Ailunce HA2 Firmware Change log Record

Ailunce HA2 Firmware V1.0.06.004-202600808

Ailunce HA2 Firmware V1.0.05.007-20260520

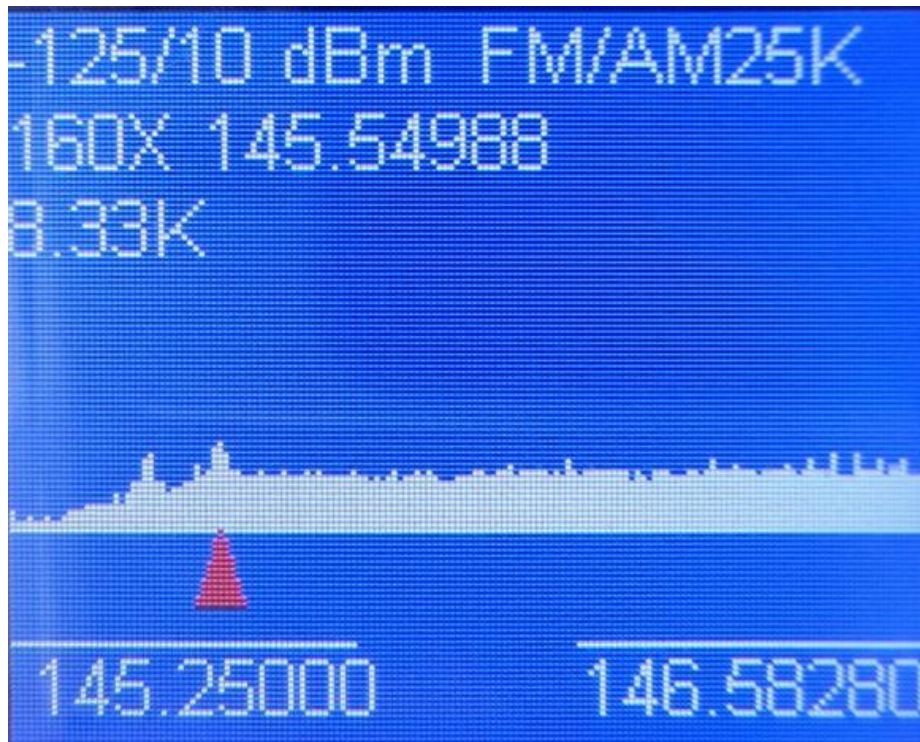
1. Add Spectrum analysis function. It allows users to visually observe the signal distribution across radio frequency bands. Through real-time scanning, users can quickly identify available frequency bands, detect interference sources, and even monitor signal activity at specific frequencies.
2. Spectrum Shortcut Key Operation Guide:
Numbers 1 and 4 adjust the lower limit of the spectrum, while numbers 2 and 5 adjust the upper limit.

Number 3 adjusts the receive bandwidth.

Number 7 adjusts the spectrum resolution.

Number 9 adjusts the step value.

* and # adjust the squelch threshold.

Use the up and down keys to adjust the frequency.
